**Change in specification of label for ELRs NV-Z series**

Flush plate type (FP-NVZS) for NV-ZSA, NV-ZLA and NV-ZHA

Before change	After change

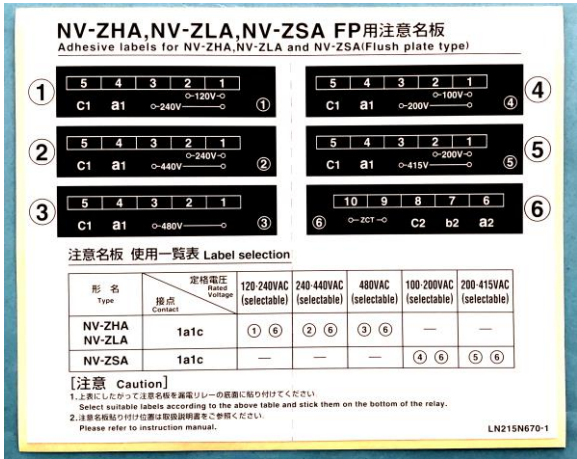
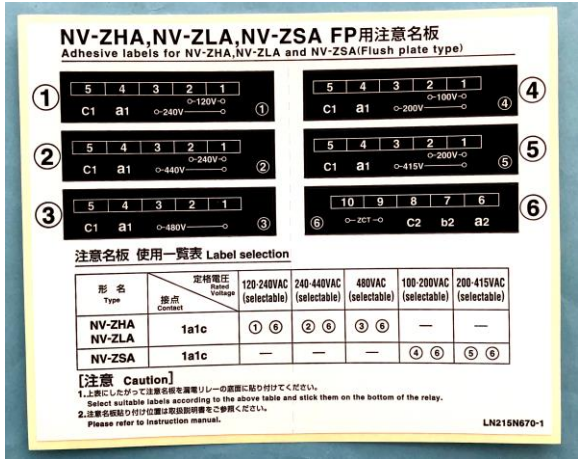
We will change the printing method.

There is no change on the label contents.
